Application of MicroLife Institute to rezone property from R-75 (Residential Medium Lot-75) zoning district to R-60 (Residential Small Lot-60) zoning district to allow for a cottage home development, at 2883 and 2893 Midway Road.

PETITION NO: N1-2025-0045 Z-25-1247356

LOCATION: 2883 and 2893 Midway Road, Decatur, Georgia 30030

STAFF ANALYSIS

PROPOSED COTTAGE PLANS/ELEVATIONS
2883 & 2893 MIDWAY RD
DECATUR, GA 30030

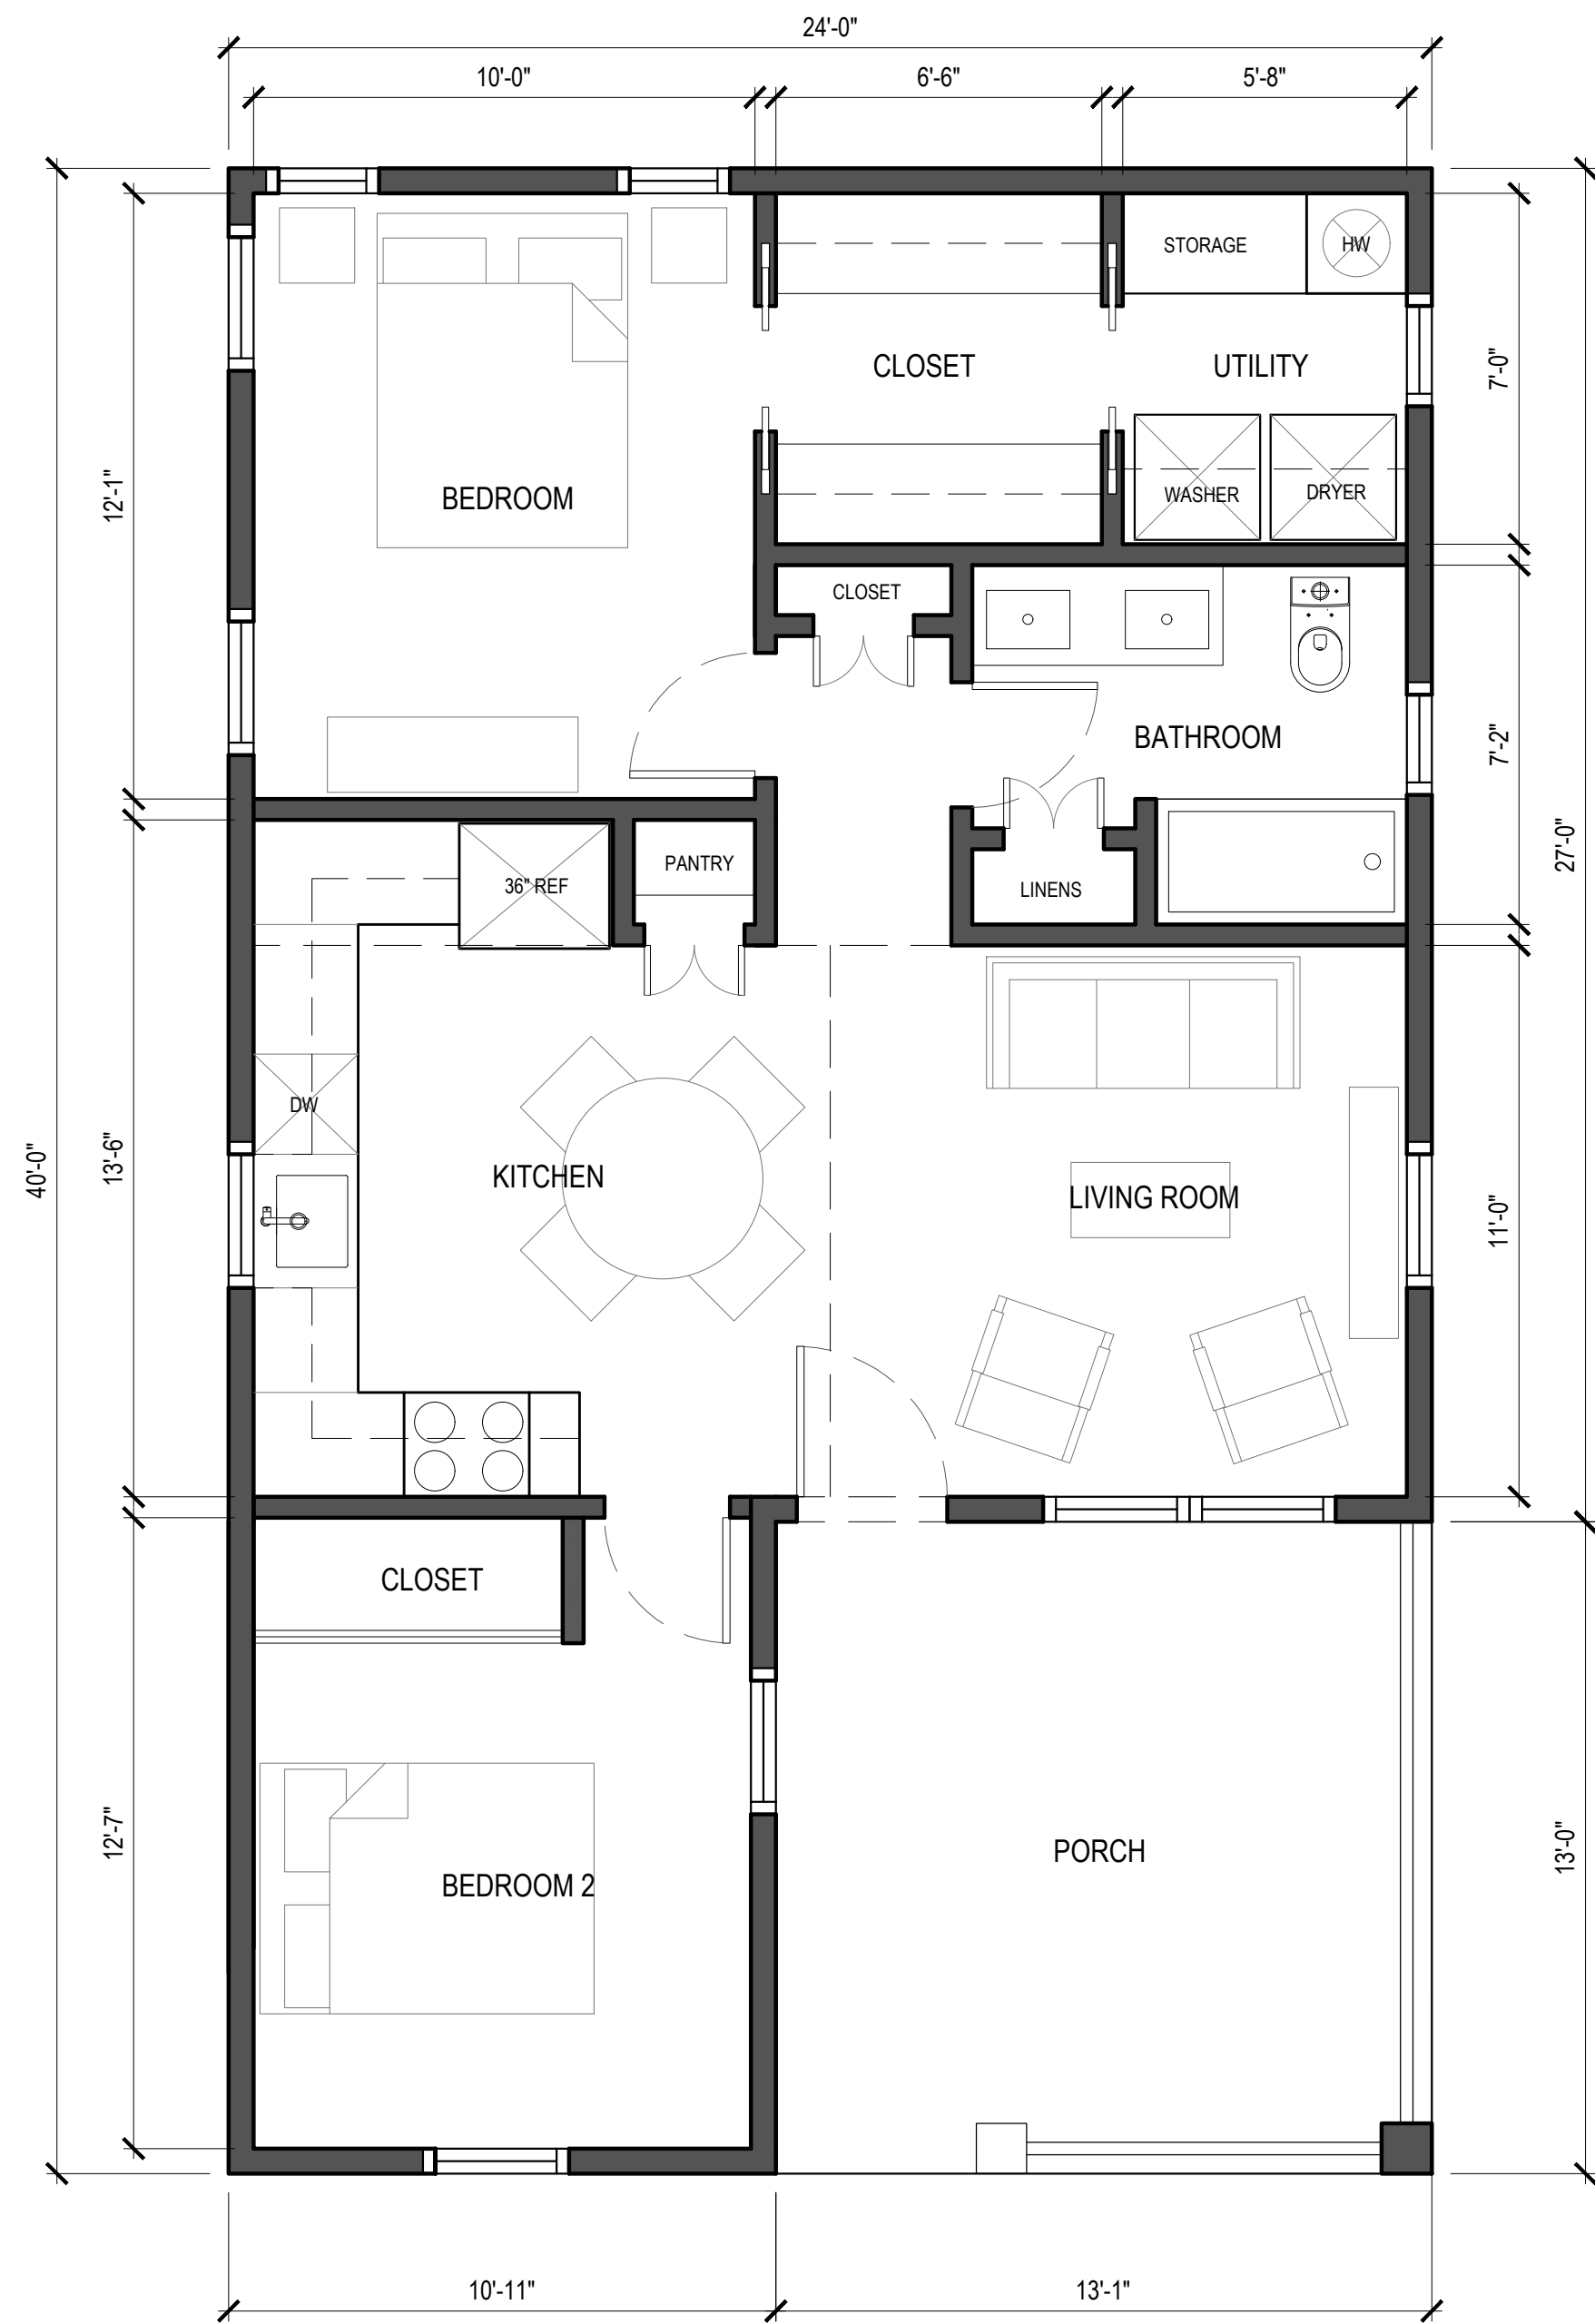
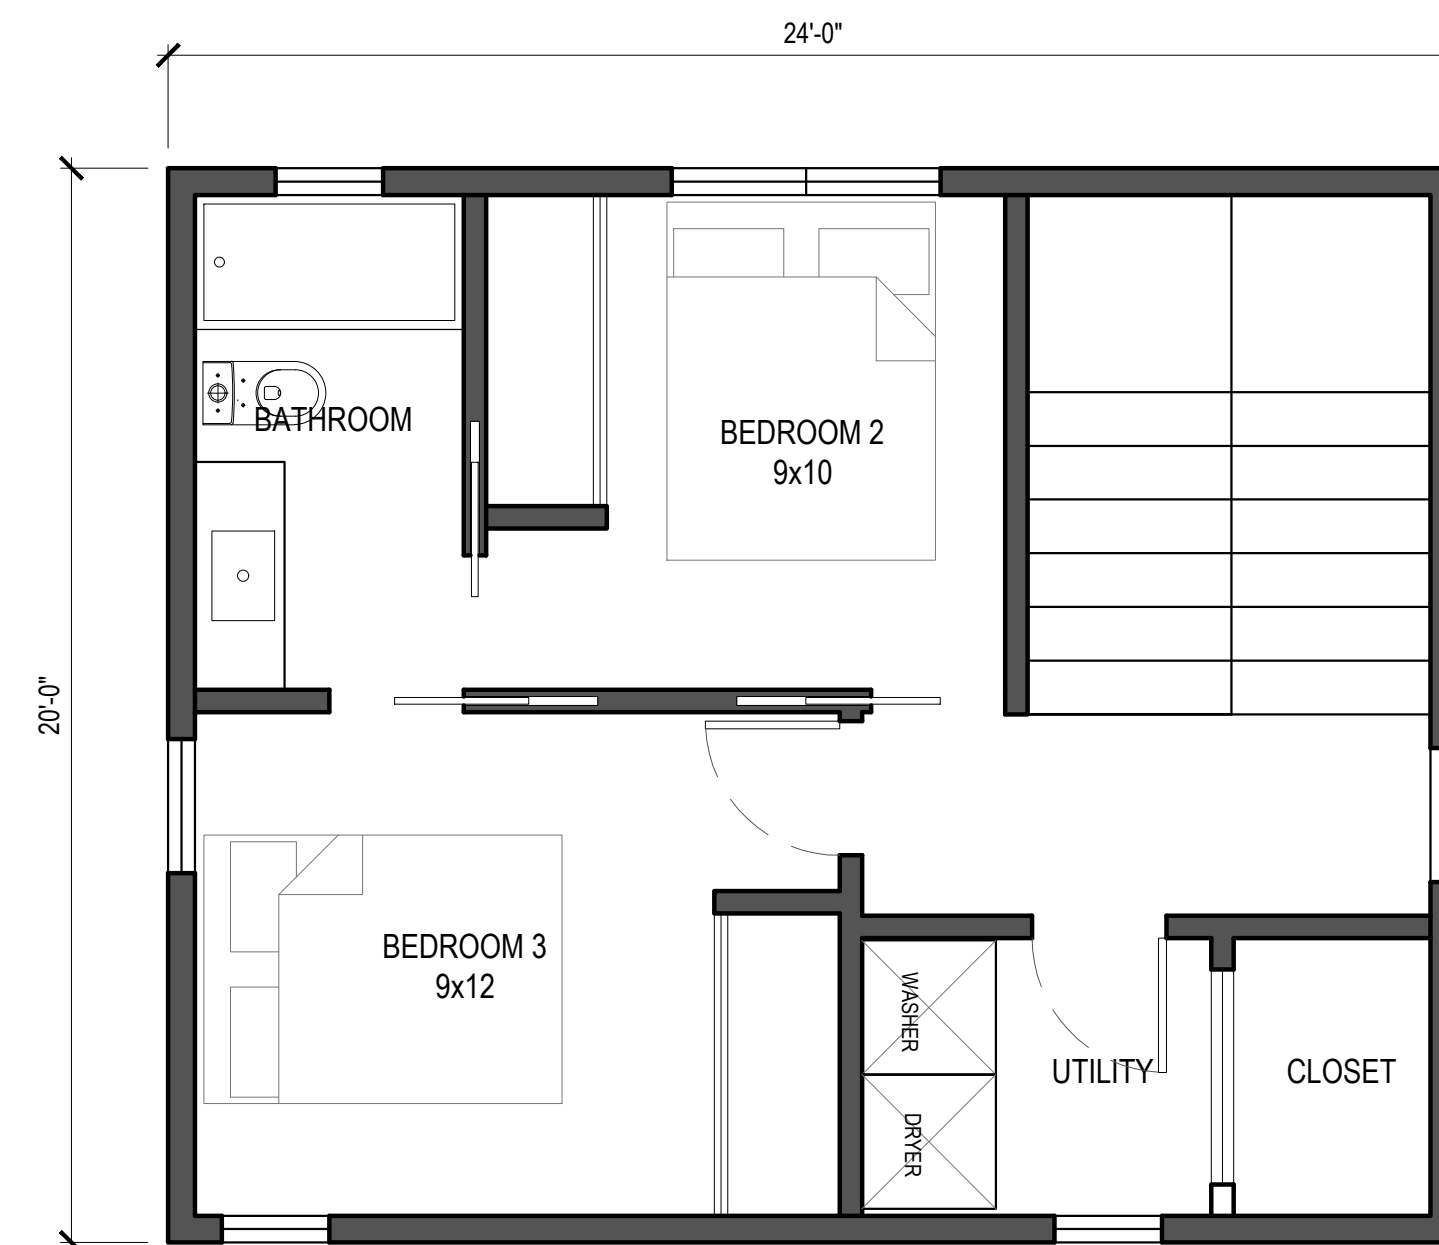
- 5) All home designs shall be consistent with the enclosed color rendering(s) entitled “2883 and 2893 Midway Road Proposed Plans/Elevations and Renderings” dated 12/16/2024, including, but not limited to architectural details and the following building materials: cementitious siding, shingle roofing or metal roofs over porches, and must comply with the applicable provisions of Article 5 *Section 5.7.9.* of the Zoning Ordinance related to building form and design.
